June 27, 2003

ULNRC- 04592

**DOCKET NUMBER 50-483
CALLAWAY PLANT
UNION ELECTRIC COMPANY
PROPOSED REVISION TO TECHNICAL SPECIFICATION 1.1,
"DEFINITIONS"; TECHNICAL SPECIFICATION 3.7.3
"MAIN FEEDWATER ISOLATION VALVES (MFIVs)"; AND
STEAM GENERATOR TUBE RUPTURE WITH OVERFILL RE-ANALYSIS
Reference: ULNRC-04845, dated May 9, 2003 (LER 2003-003-00)**

Figure 15.6-3.2.h: Steam Generator Atmospheric Release Flow Rate (Intact Generators) Transient for SGTR Event with Overfill

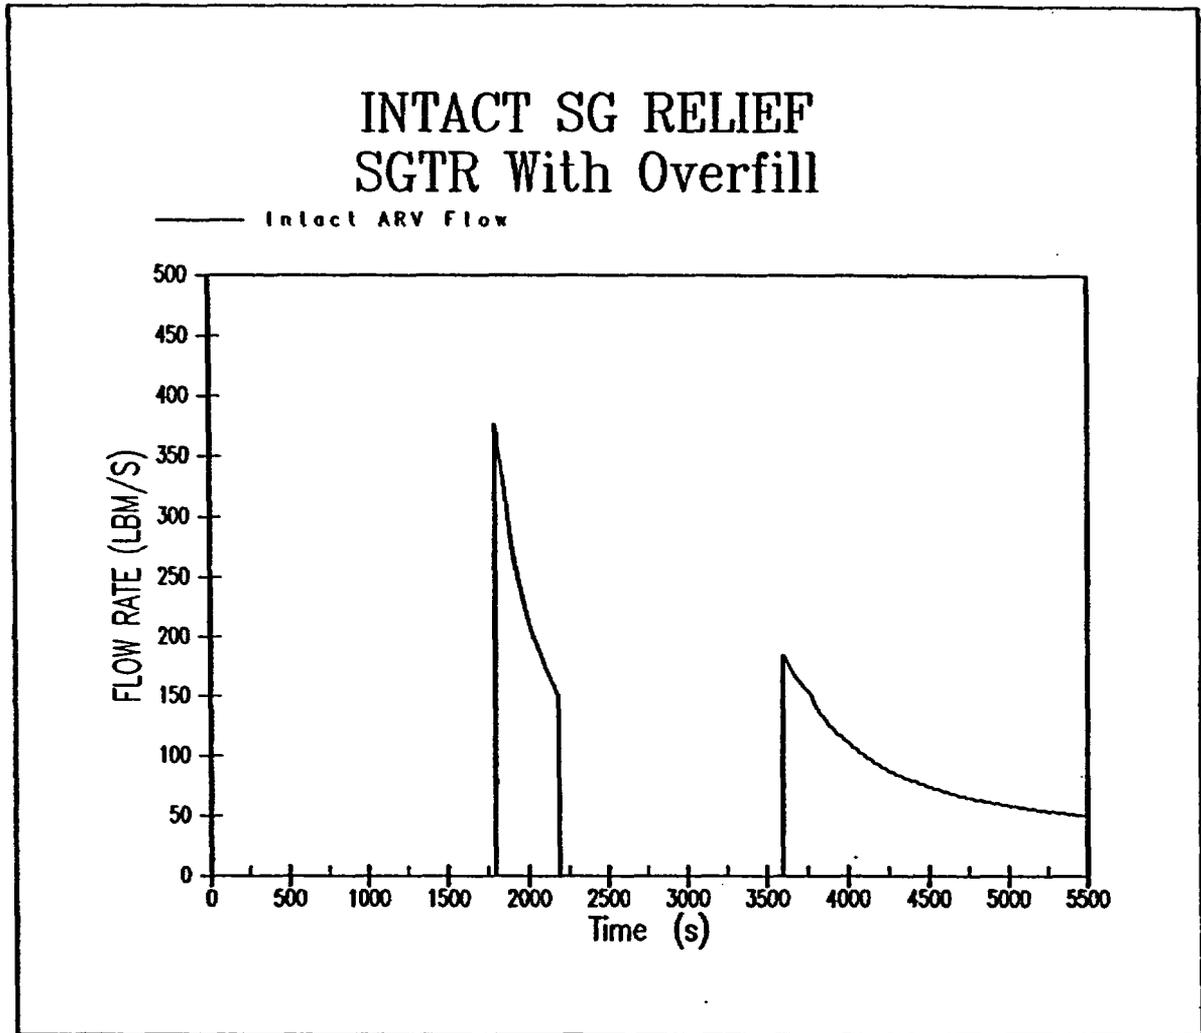
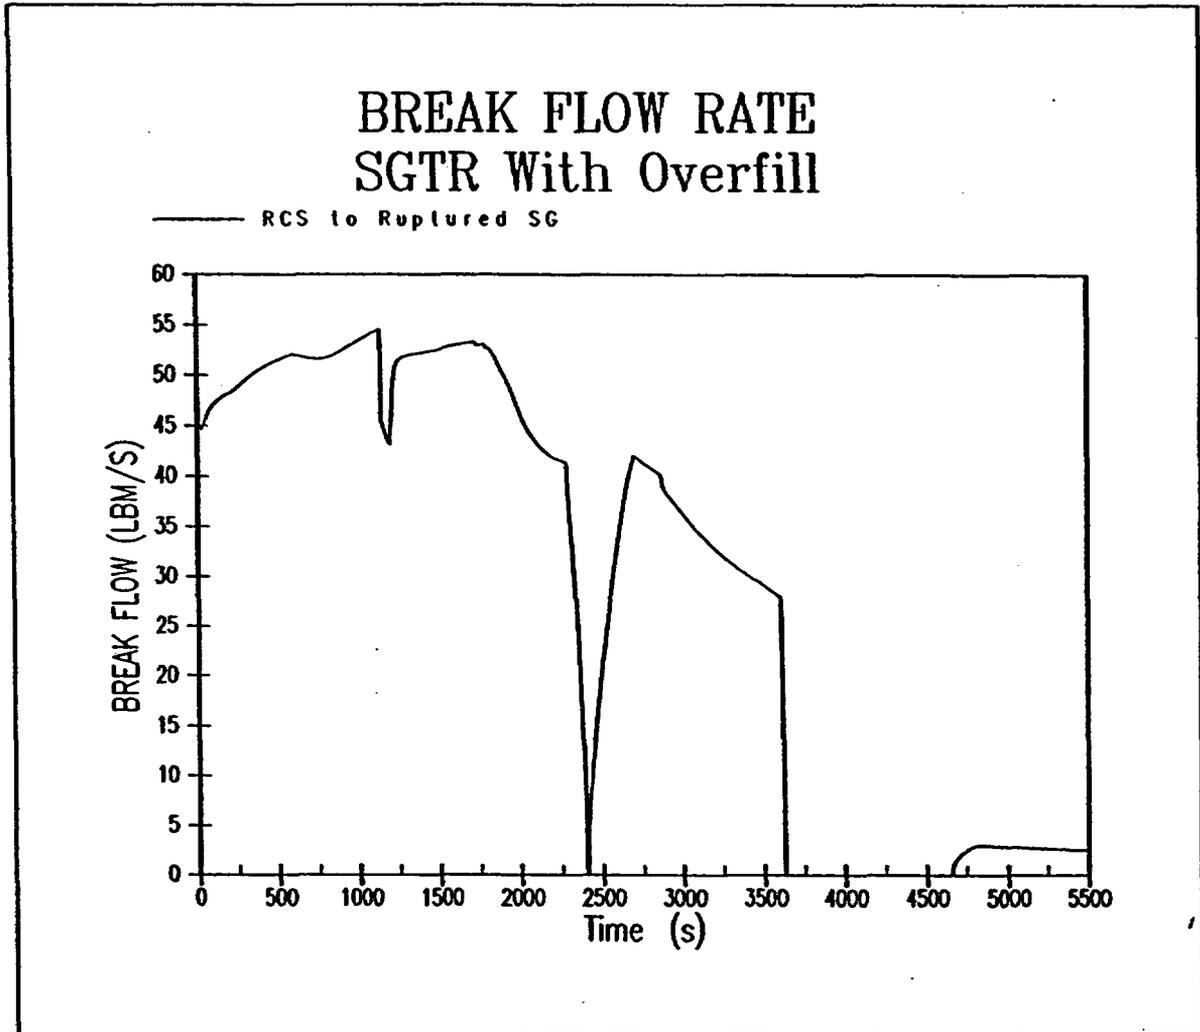
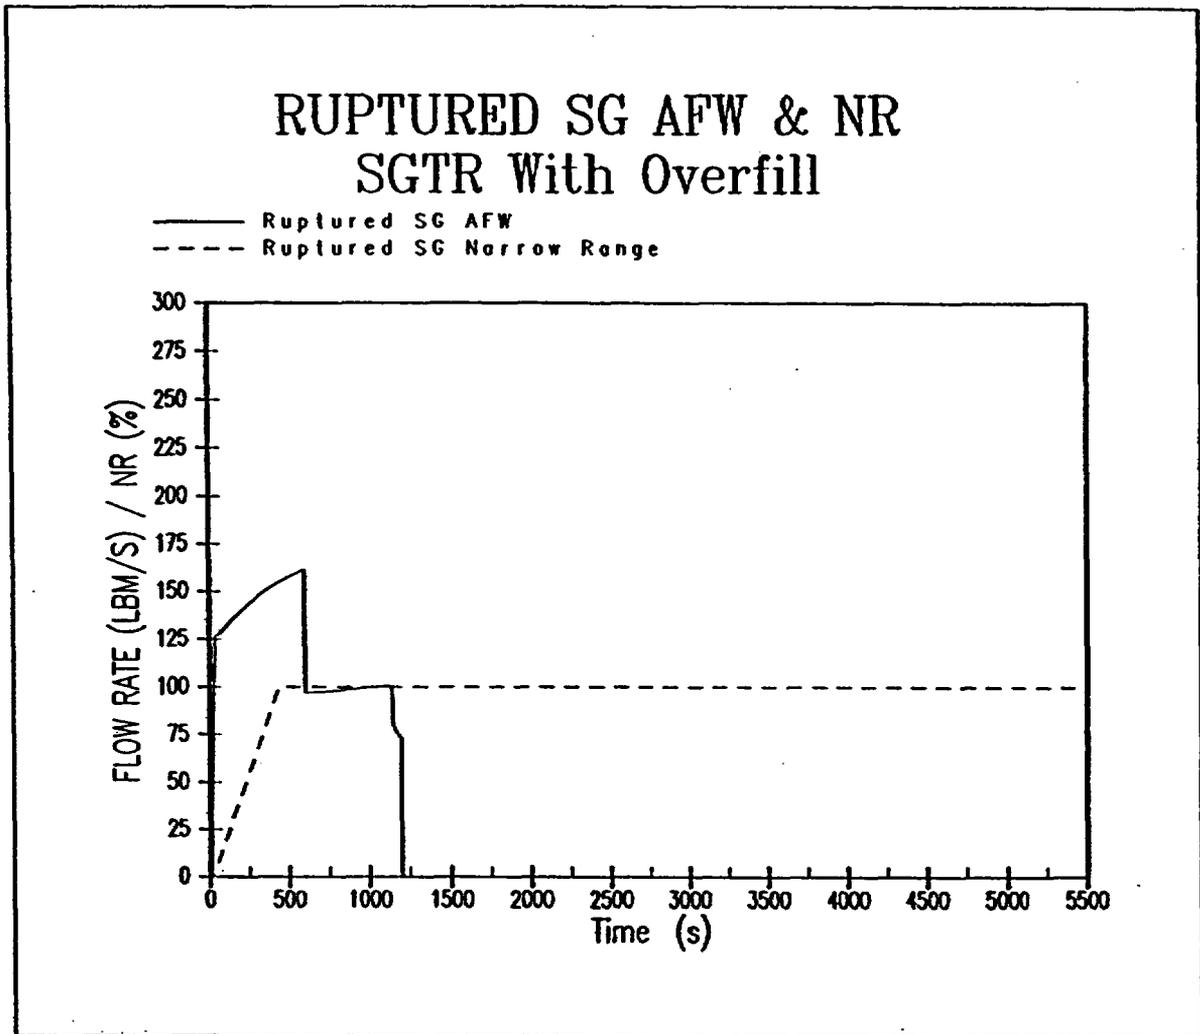
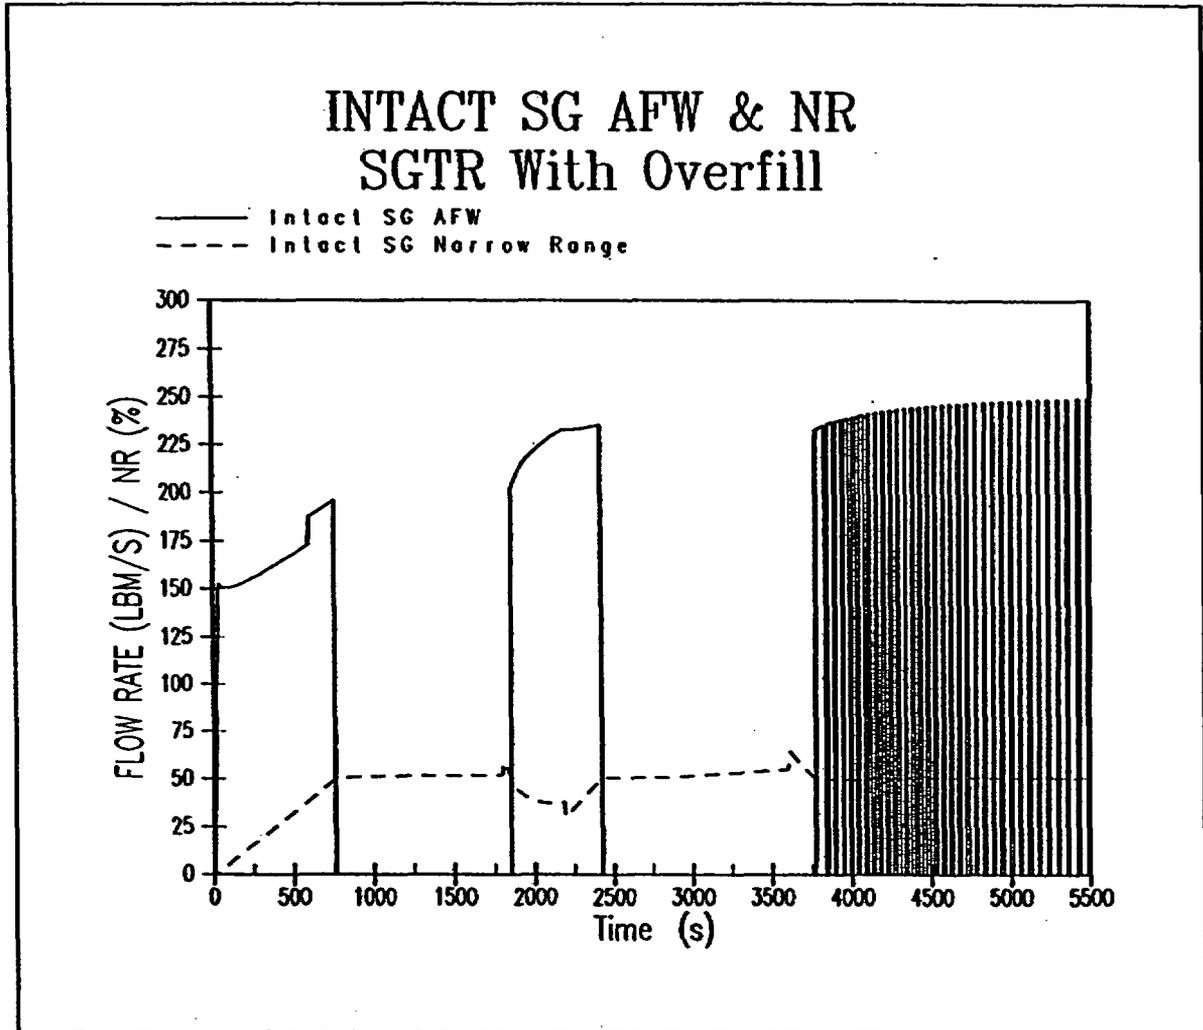
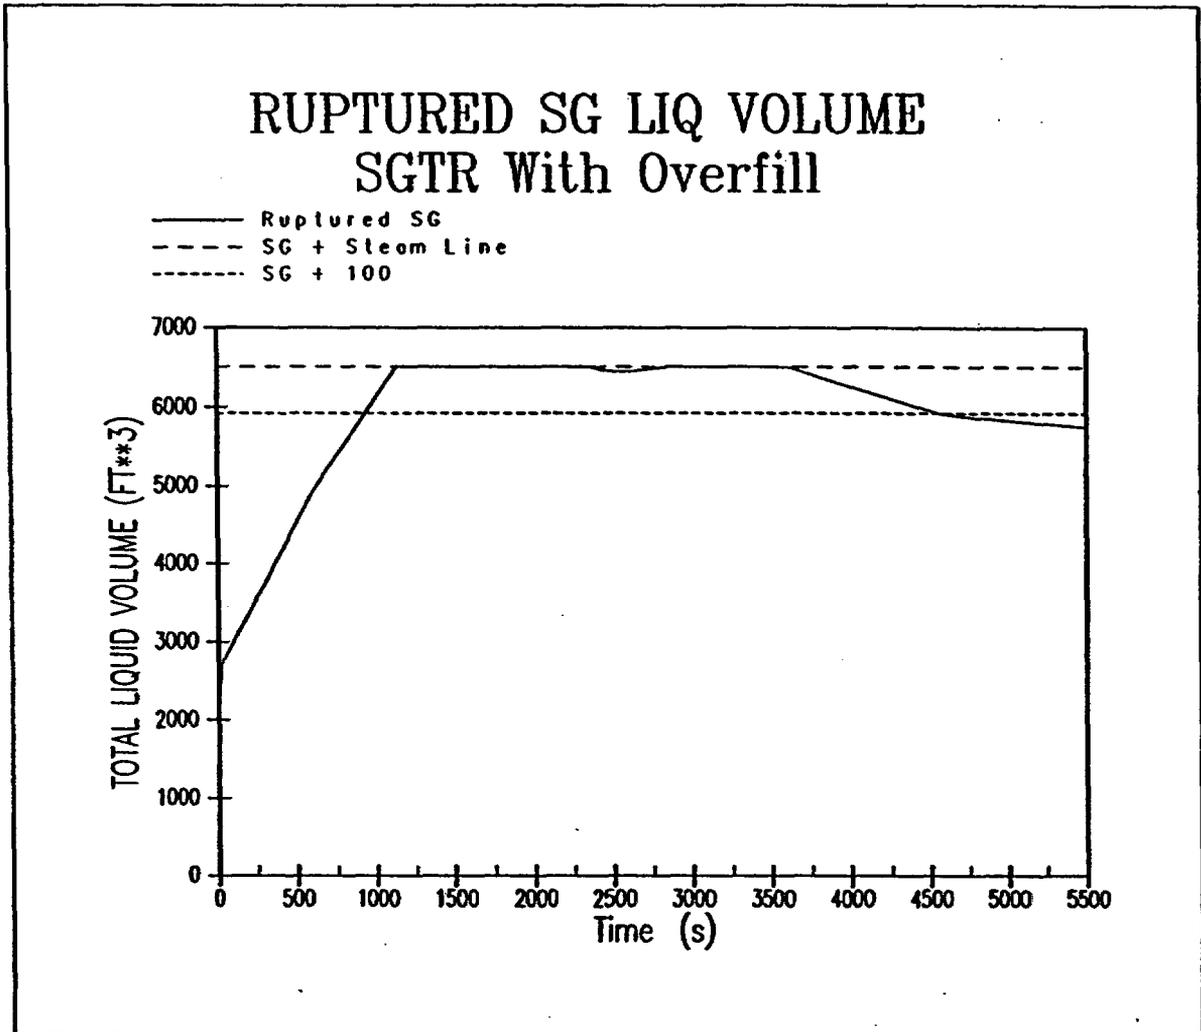
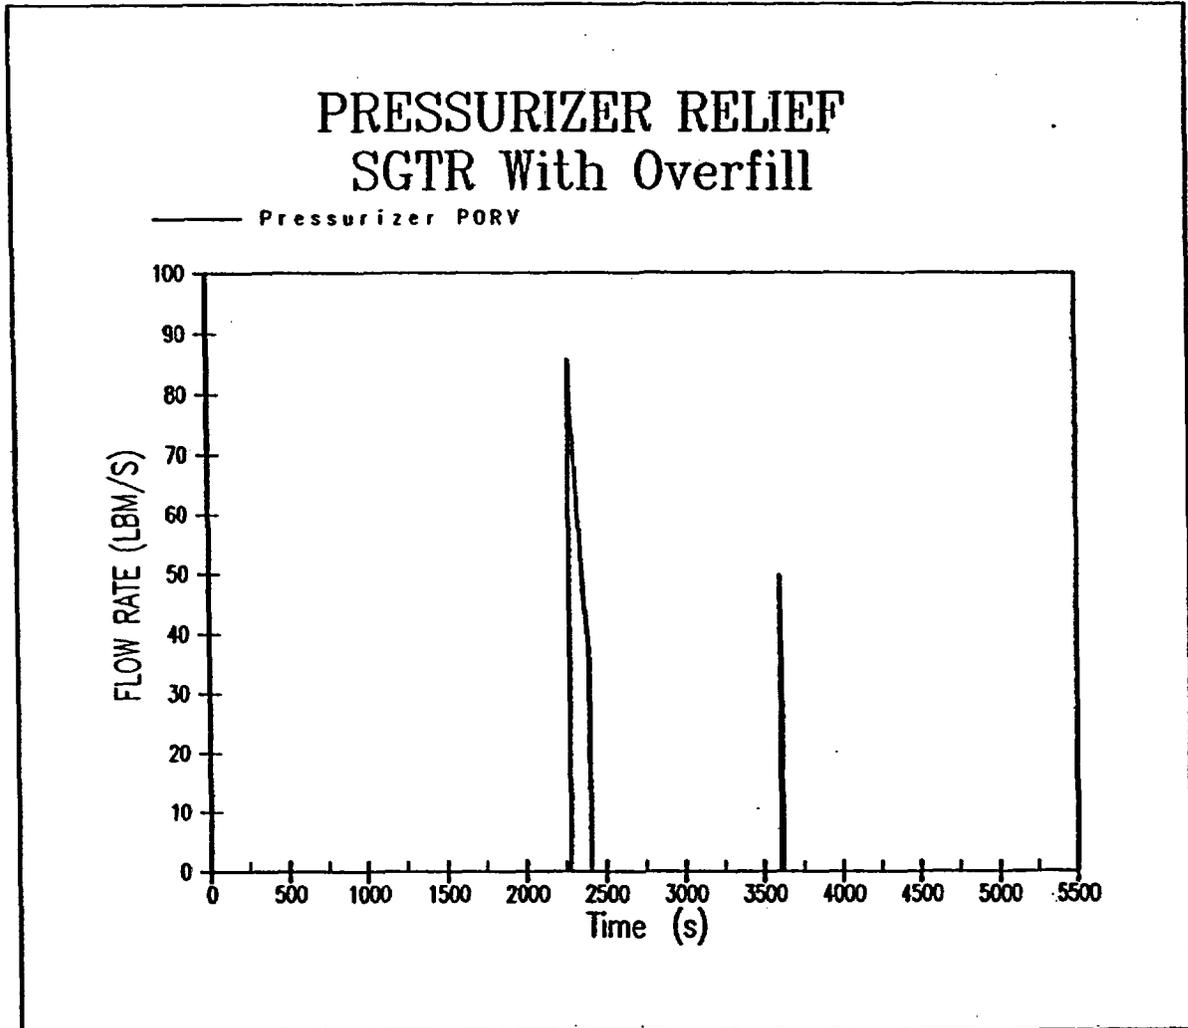
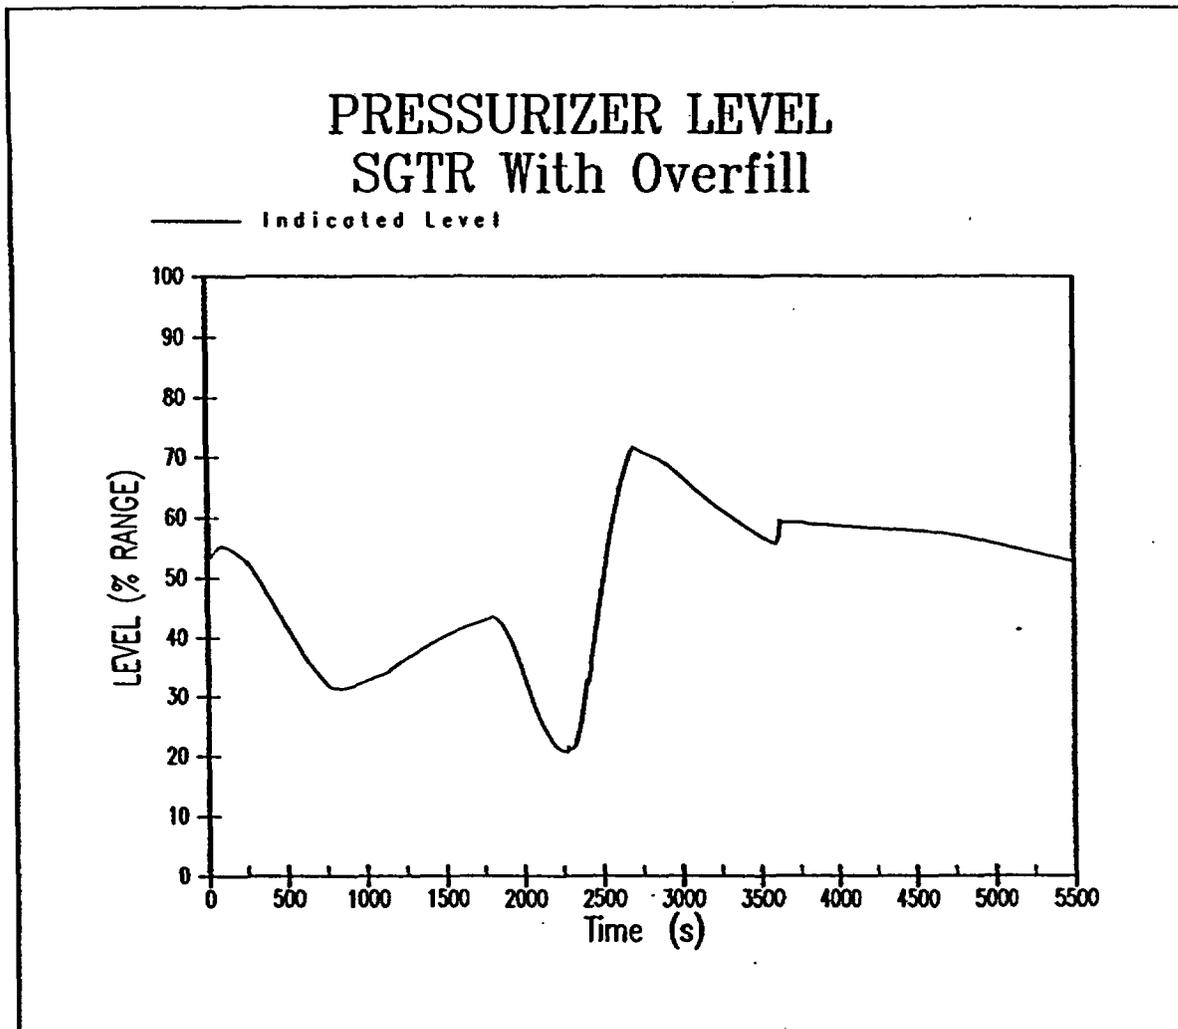
- The Section 15.6.3.1.3 dose analysis conservatively modeled a constant break flow rate. For the analysis of doses for the overfill case the transient break flow rate from the RETRAN analysis presented in Figure 15.6-3.2.i is used, up until the time when water relief stops. This is consistent with the analysis approved in Reference 3.

- k. The ruptured SG releases are modeled using the RETRAN analysis results presented in Figure 15.6-3.2.g. In the calculation of doses for the cooldown to RHR conditions it is assumed that a steam flow rate of 8 lbm/sec is maintained due to the failed open safety valve. Thus, 144,000 lbm of steam is released from the ruptured SG in the 5 hours from break flow termination until RHR conditions are reached.

- l. The intact SG releases are modeled using the RETRAN analysis results presented in Figure 15.6-3.2.h. In the calculation of doses for the cooldown to RHR conditions it is assumed that 4000 lbm of steam is released from the intact SGs from the time of break flow termination. This value was conservatively calculated

DIAGRAM FOR MFIV SYSTEM-MEDIUM OPERATED ACTUATOR

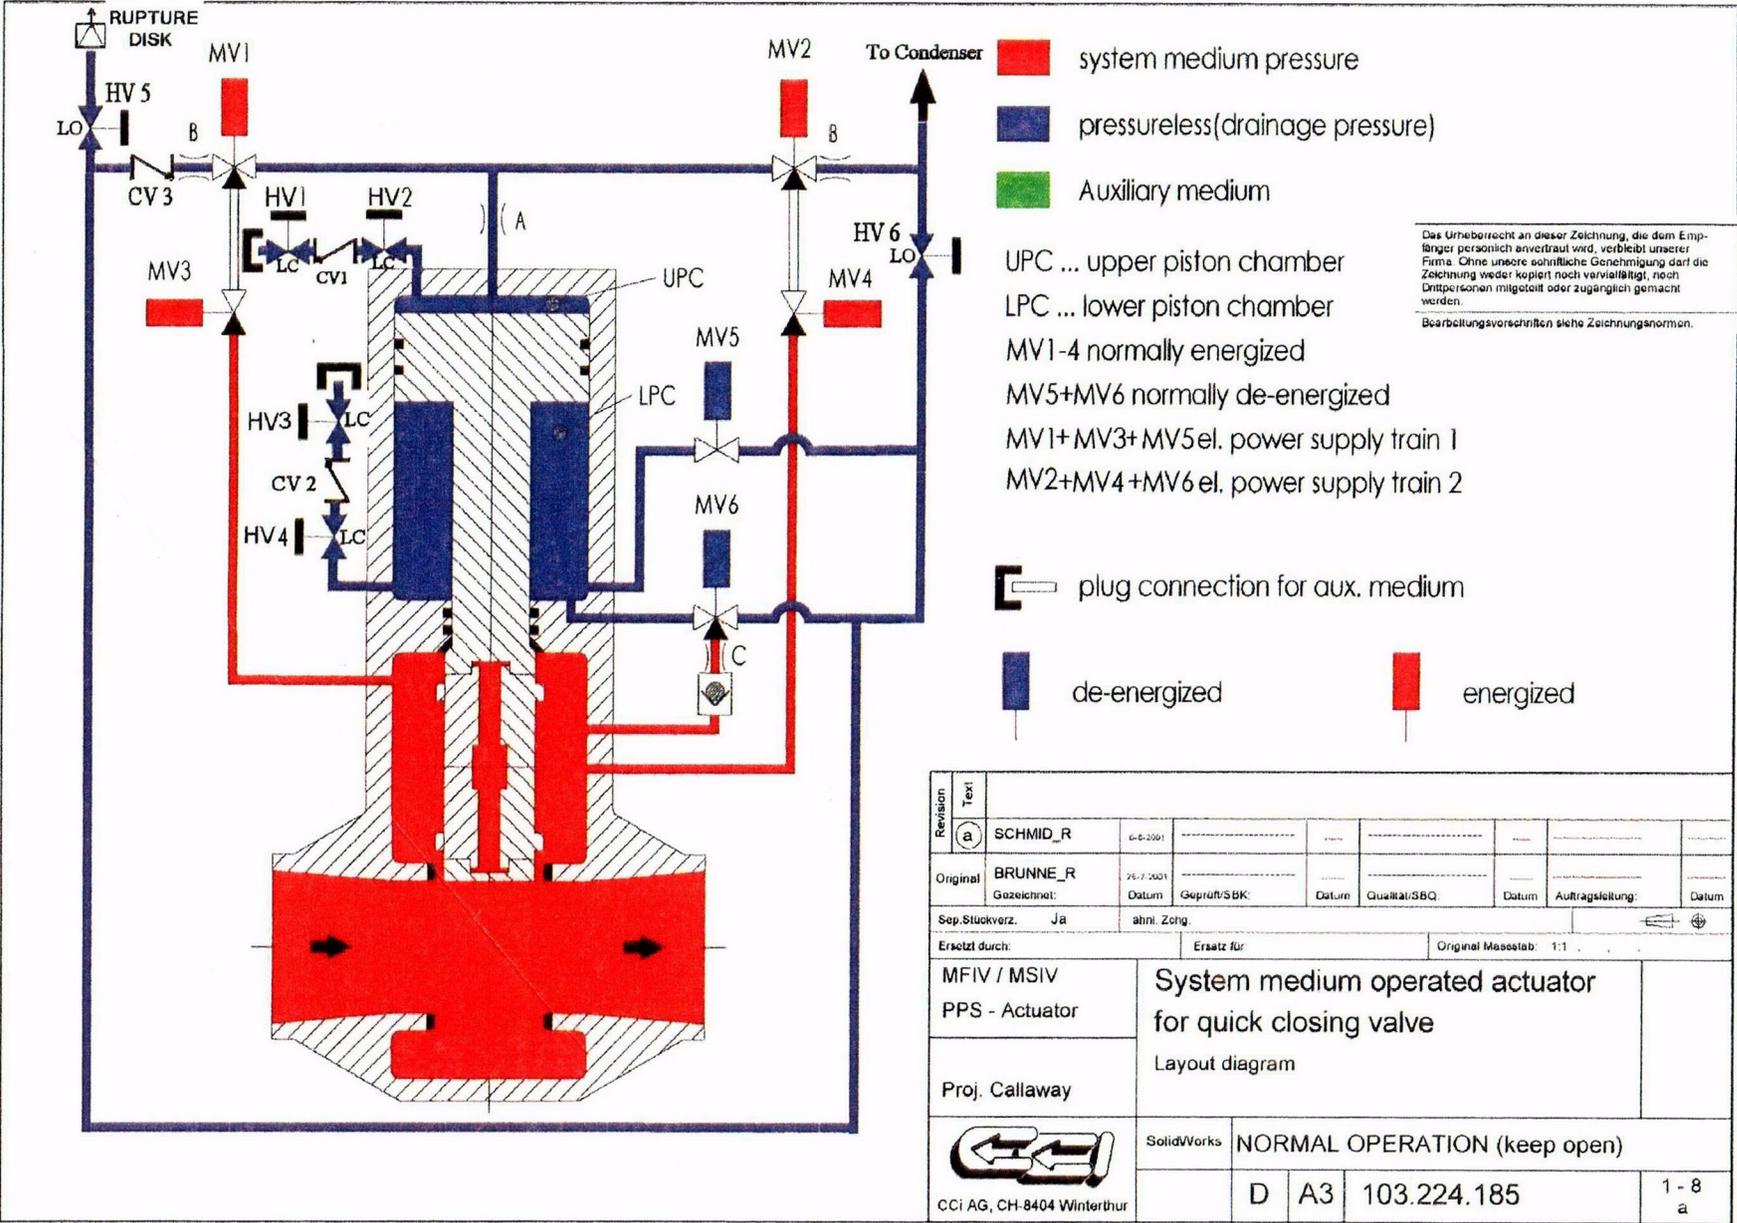
The existing electro-hydraulic actuators for the Main Feedwater Isolation Valves (MFIVs) have a poor maintenance history. The valve actuators are complex and have numerous O-rings under high pressure. The history of these valves includes leaks that have resulted in loss of generation capacity, and delays in starting up the plant following refueling outages, as well as increased personnel exposure to hazardous materials (use of the hazardous material, fyrequel, associated with the electro-hydraulic actuators). As a result, the existing electro-hydraulic actuators on the MFIVs will be replaced with system-medium actuators during Refuel 13. To accommodate the new actuators, the existing valve bonnets and yokes will be removed, and a new bonnet installed.

The safety design functions of the MFIV actuators are to close the MFIV within the required time frame and provide an acceptable pressure boundary for the Auxiliary Feedwater System, when closed. The proposed TS change will increase the required MFIV closure time from 5 seconds to 15 seconds.
